SEABROOK STATION

REQUEST FOR FOLLOW-UP ACTION NRC INSPECTIONS

NRC Questions

REVIEW OF AUTOMATIC ORBITING GTAW BUTT WELDING

Pictures of some of the damaged nozzles: (A) (B) (C)

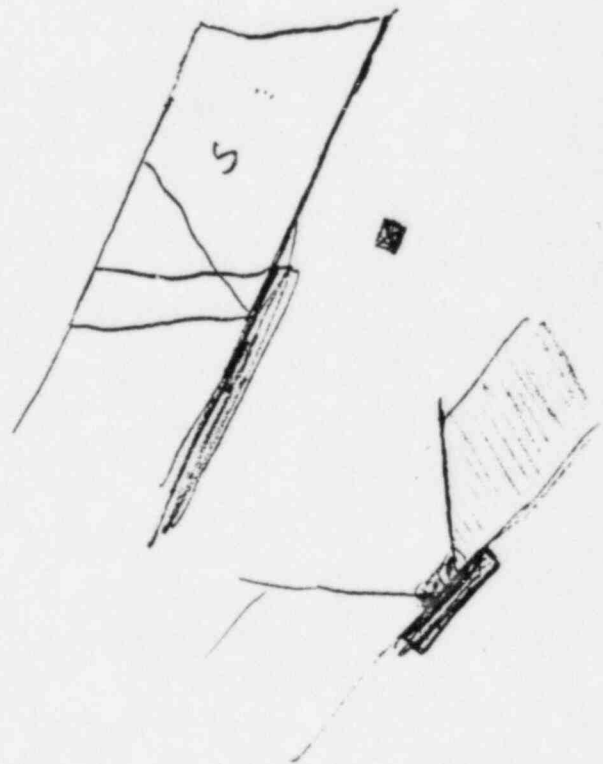
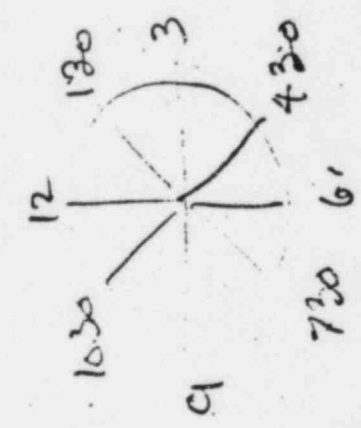
Nozzle (a) - Minimal mechanical damage marks noted in root face area.

Nozzle (b) - Considerable mechanical damage by indentations and plastically deformation (bending) to root face area. No weld beads noted in root face area.

Nozzle (c) - Clamp or round hammer mark noted at 035° in weld joint bevel. Damage to root face area for a length of approximately 10 inches at 270°.

Nozzle (d) - Area 10" long appears to be ground below tolerance for consumable insert root pass welding.

Nozzle (e) - Plastically deformed area of root face approximately 6 inches long. Apparent weld bead (spot) noted. This is the nozzle inspected at four locations in November 1980 by an NRC Inspector. The damage to the root face area was not noted at the November inspection.

Nozzle (f) - Apparent weld bead noted on root face area. Mechanical damage to root face area.

The mechanical damage noted was for the most part in the root face area and consisted of mechanical indentations made by a blunt instrument (not like a welder's scaling hammer sharp indentation) and plastically deformed (bent) root face nose. The damage to the root face areas would render the joint unweldable by consumable insert techniques.

RPV Damage — 5 of 8 nozzles have hammer
(Unit 2) blow damage on end preps
